ADDENDUM NO.: 2

DATE OF ADDENDUM: February 3, 2016

**MASONRY SHOP + FITNESS CENTER  
BULLARD-HAVENS TECHNICAL HIGH SCHOOL  
500 PALISADE AVENUE  
BRIDGEPORT, CT  
BI-RT-876**

DRAWING NO:  
**SK1-EP-101**  
 DATE: 2/3/2016  
 SCALE: 1/8"=1'-0"

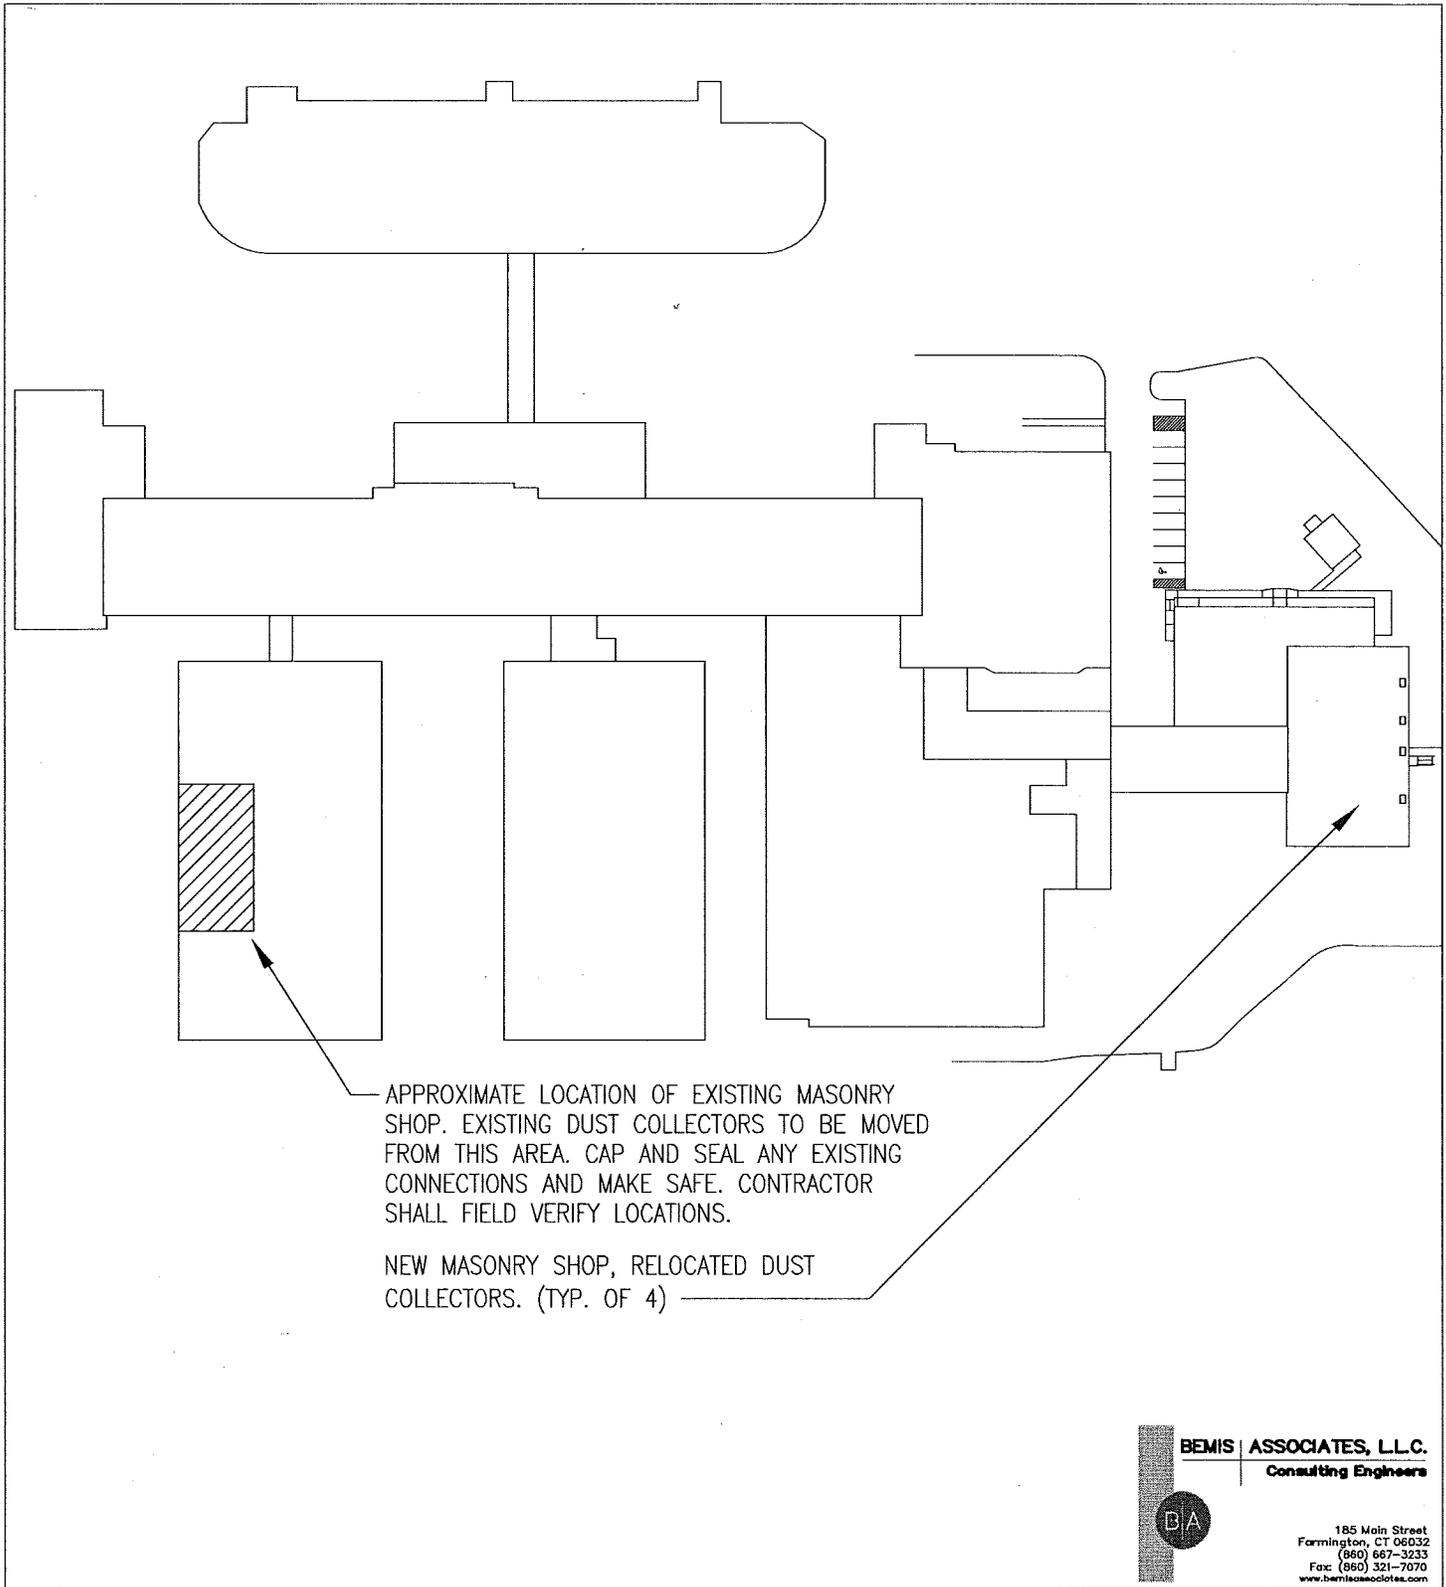
- o Delete Manual Starter for REF-2
  - o Provide power for new Dust Collector. Refer to SK1-EP-101
- See SK1-EP-101 attached.**

DRAWING NO:  
 SK1-M-101

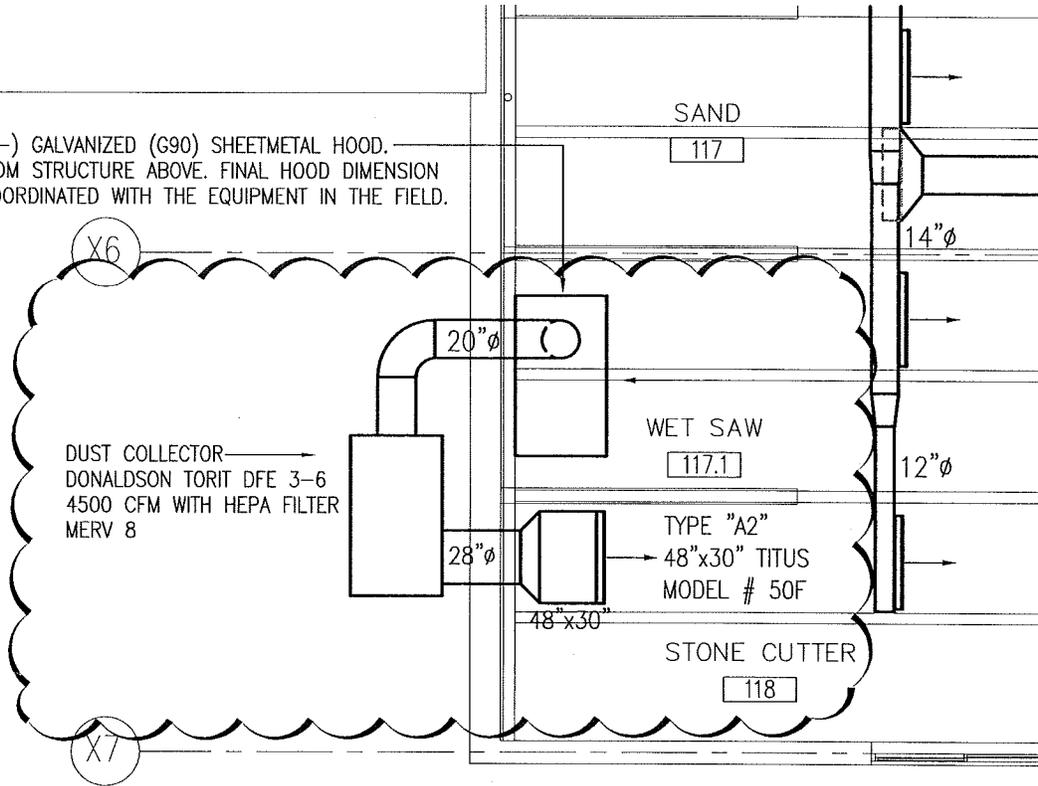
" M-101 the 4 dust collectors is the contractor responsible to disconnect and move them to the new location. Show on the drawings where they are located."

-- See attached SK-1-M-101

84"x48" (+/-) GALVANIZED (G90) SHEETMETAL HOOD.  
 SUPPORT FROM STRUCTURE ABOVE. FINAL HOOD DIMENSION  
 SHALL BE COORDINATED WITH THE EQUIPMENT IN THE FIELD.

SK2-M-101

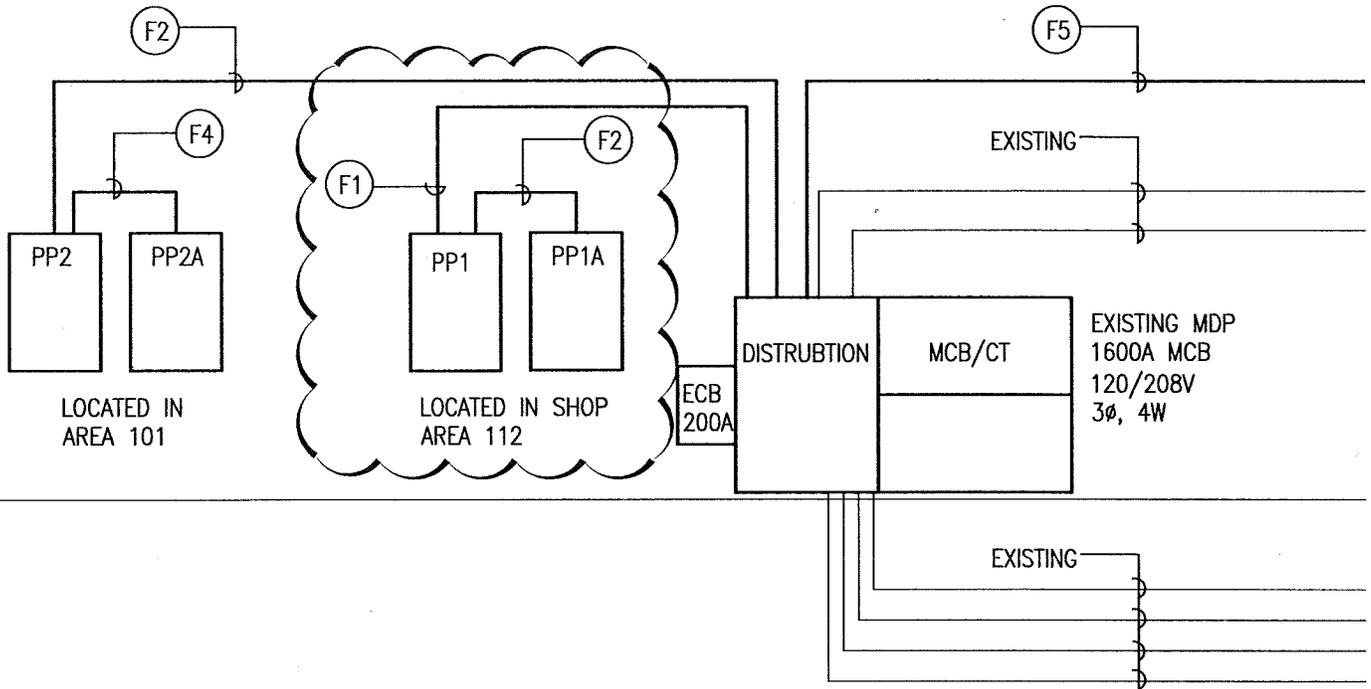
- o In Jan 111, delete reference to venting for domestic water heater (WH)
- o Provide 6" concrete pad for new Dust Collector.
- o Thermostat in the N-E corner shall control MAU-1
- o Thermostat in Lockers 109 shall control MAU-2.
- o Provide 48"x30"x30" discharge air plenum for the dust collector. Provide 48"x30" Type A2 Titus model 50F discharge grille in lieu of the 48"x24" type B register. Refer to SK2-M-101.
- o Type A2 Diffusers associated with the relocated dust collectors shall be 48"x30"
- o Return for MAU1 and MAU2: provide (2) 48"x48" Type A2 Grilles

**See SK-2-M-101 attached.**
